LINCOLN CITY/LANCASTER COUNTY PLANNING STAFF REPORT

for August 20, 2003 PLANNING COMMISSION MEETING

P.A.S.: Change of Zone 2751A
Amendment to Van Dorn Acres PUD

PROPOSAL: Amend the Van Dorn Acres R-3 Residential PUD, for 220 residential units, 33,000 square feet of commercial floor area for uses allowed in the B-1 Local business District, and the sale of alcohol within 100' of a residential district or residential use.

SITE PLAN

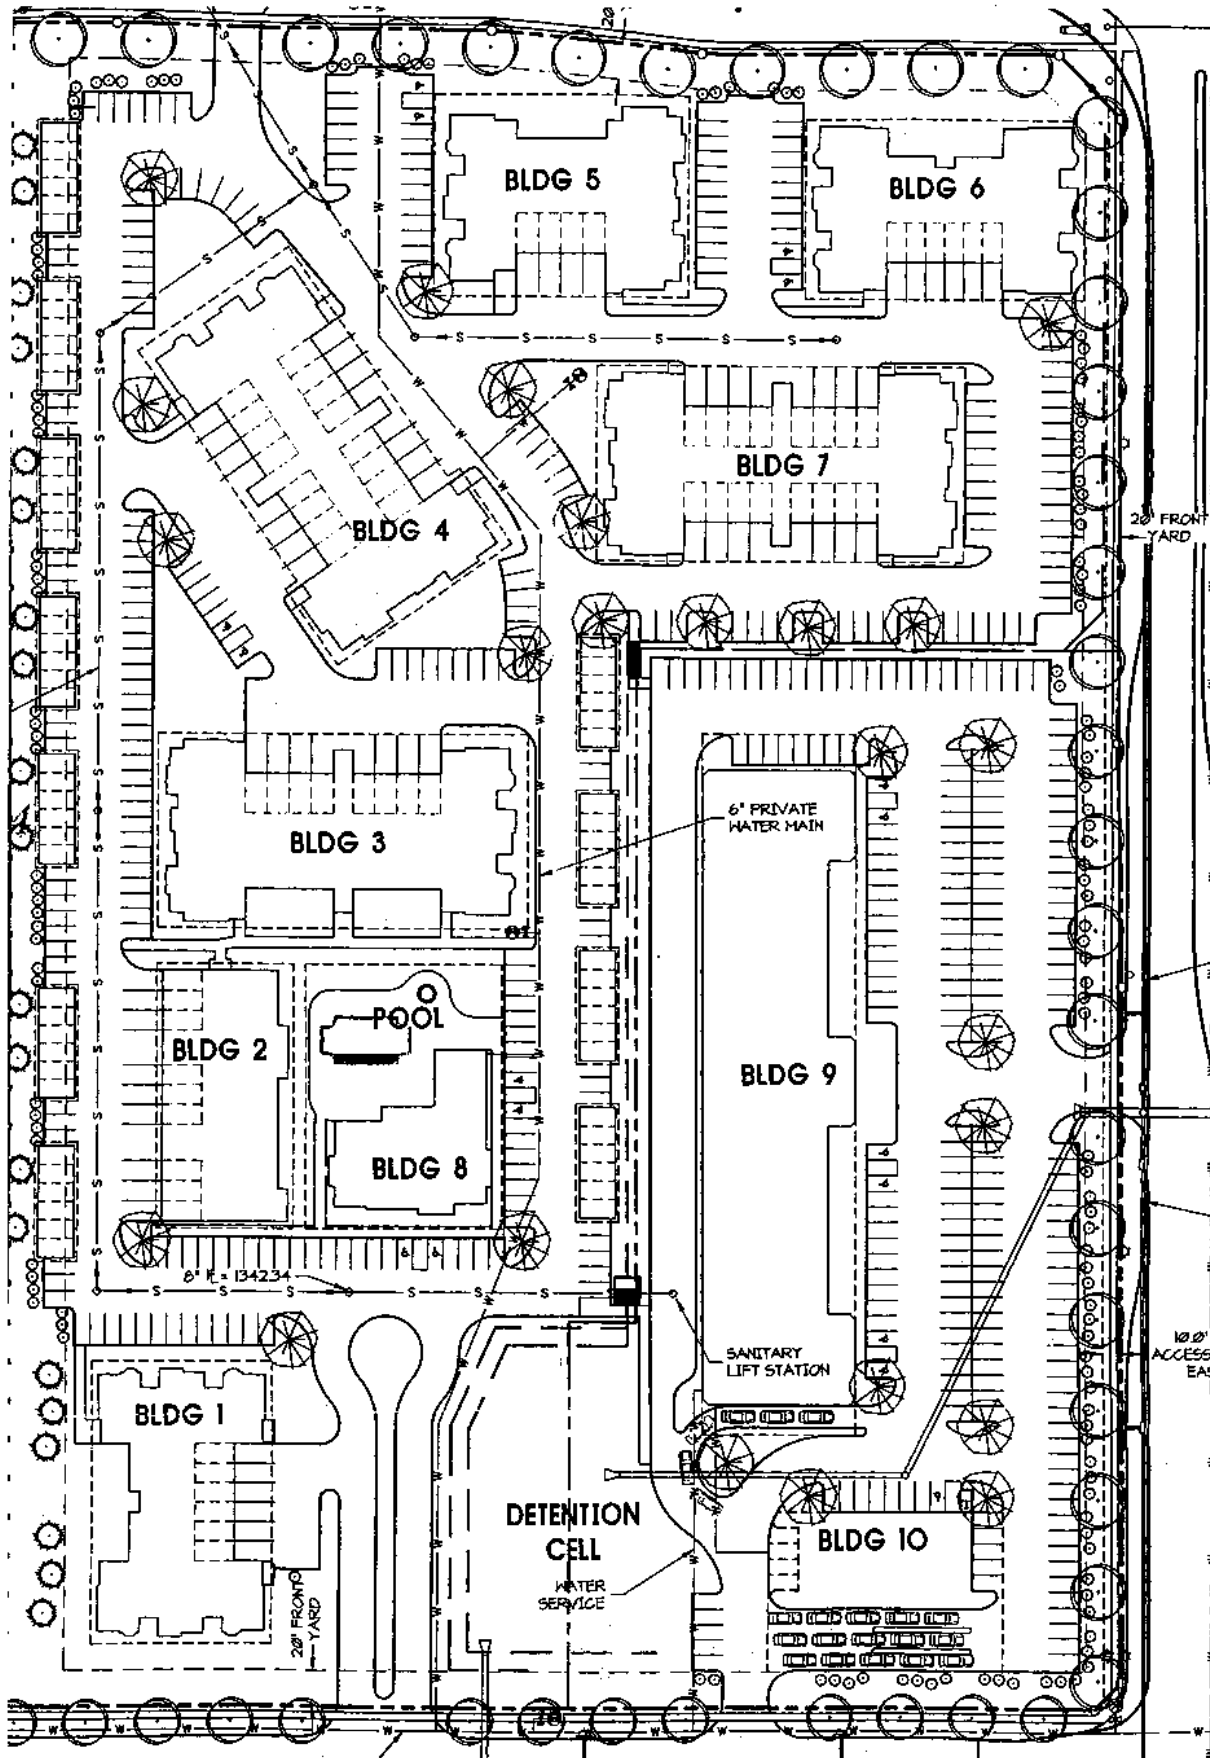
- 1.1.15 Add a note stating that 3-story buildings shall be setback at least 70', 2-story buildings shall be setback at least 35', and garages shall be setback at least 20' from the property line. Revise the drawing accordingly.

- 1.3.1 Show 2' contours.
- 1.3.2 Provide information about the detention cells showing stage/storage/discharge values, outlet structure details, and more detailed grading information.
- 1.3.3 Revise the peak inflow calculations to Cell #2 to account for the outflow of Cell #1.
- 1.3.4 Revise the Basin A3 runoff calculations.
- 1.3.5 Provide 2- and 10-year storm event calculations.
- 1.3.6 Show an internal storm sewer system.
- 1.3.7 Show that all drainage that is assumed to reach the detention cells has a route to get ther via storm sewer or overland flow.
- 1.3.8 Submit written documentation evidencing that the Applicant has permission to construct cell #1 on off-site property. A verbal

- 1.3.11 Show emergency spillways with a clear overland flow path for both detention cells.
- 1.3.12 Obtain a Section 404 permit from the Army Corps of Engineers for fill on this site, or provide documentation that such a permit is not required.

- 1.3.13 Show on-site fire hydrant locations.
- 1.4 Revise sheet 2C of 8 for the approval of the Public Works & Utilities Department to show:
 - 1.4.1 Provide calculations and documentation showing that the downstream sanitary sewer has the available capacity to serve this development.

- 1.4.2 Show the method of sanitary sewer service to Building 10.
 - 1.4.3 Revise the water system to show only one water meter per lot. Also, show water meter locations in an above ground structure or in the mechanical room of a proposed building.
